Appendix A – Zoning Only Version 10/10/25 LH Comments (purple) for Expert’s consideration and responses.

#	Specific Request	Reasons for request	Applicant response	1 <sup>st</sup> Clause 23 Request: Satisfied/ Not Satisfied	If 1st clause 23 Request Not Satisfied – outstanding information and / or Additional Clause 23(2) Request	Applicant response to Clause 23(2) Requests for original Clause 23(1) requests either Partially Satisfied or Not Satisfied	2 <sup>nd</sup> Clause 23 Request: Satisfied/ Not Satisfied	If 2nd clause 23 Request is still relevant after the changes made to request and is Not Satisfied – outstanding information and / or Additional Clause 23(2) Request	Applicants response to 3 <sup>rd</sup> request
<b>Ecology – Thomas Consultants</b>			Refer to the Memo “40 Mahi Road: Ecologists92 Comment” dated 17/02/2025 and associated updated ecological report. Comments also set out below.						
E1	Please provide an updated vegetation map for the site.	The vegetation assessment described in the Ecological Assessment report prepared by Thomas Consultants was carried out 21 months ago, and the report indicates that some changes to the vegetation cover have occurred since that time

Figure 5: A snip from amended precinct plan (Civix Ltd.) showing amended legend and "Potential Riparian Areas"

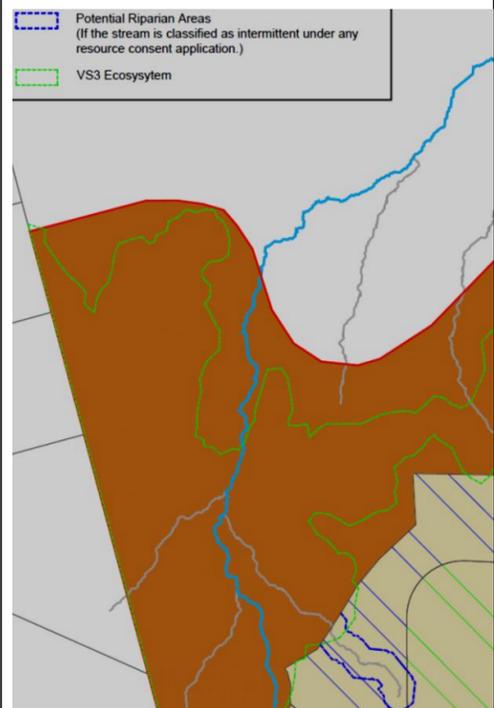
E2	Please provide an updated watercourse map for the site that clearly illustrates the appropriate classification for each stream.	There is some ambiguity regarding the stream classifications. The Ecological Assessment report indicates that “Stream 3” and “Stream 6” are both ephemeral, and therefore would not be subject to riparian margin/yard restrictions. However, the Proposed Precinct Plan prepared by Civix indicates “potential riparian areas” along these streams where they extend into the proposed SHZ. Clarity should be provided regarding the status of these streams. Also, if some gorse has now been removed, areas of stream that were previously inaccessible may now be able to be assessed in more detail.	Refer to Section 5.4.1 and Appendix A of the updated Ecology Assessment for a description of all watercourses on site and a map of all watercourses and their classification. I am confident that Stream 6 is ephemeral, and that Stream 3, where it flows through the more ‘open’, proposed Single House Zone (SHZ) areas, is also ephemeral.  Watercourses were classified and delineated (where accessible) on site in general accordance with criteria outlined in the Auckland Unitary Plan (AUP:OP) Chapter J Definitions. Stream 3 and Stream 6, where they flow through proposed Single House Zone (SHZ), were both classified as ephemeral (and not intermittent) due to their small catchment size <sup>1</sup> (1.08 ha for Stream 3 and	Satisfied	Revised map is satisfactory.	N/A	N/A	N/A

The Precinct Plan's legend has been amended to "Potential Riparian Areas (if the stream is classified as intermittent under any resource consent application)". See Figure 5 next page.

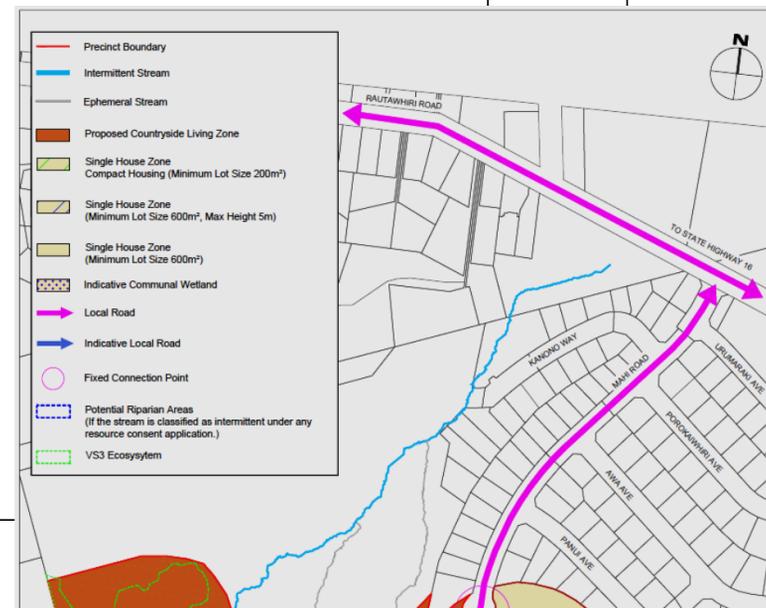
UD4 Please provide a scaled concept masterplan and precinct plan.

It is noted that the concept masterplan and the precinct plan are not to scale. A scaled map will provide a better understanding of the individual subdivision lot size and widths of proposed JOALS.

I note that the Precinct Plan has now been amended to better reflect the Council's style guide, and this is included in the email supplying this response and also illustrated below. It is noted that the style guide enables some degree of complexity where there are different zones and overlays proposed as stated below:

Scaled precinct plan has been provided.
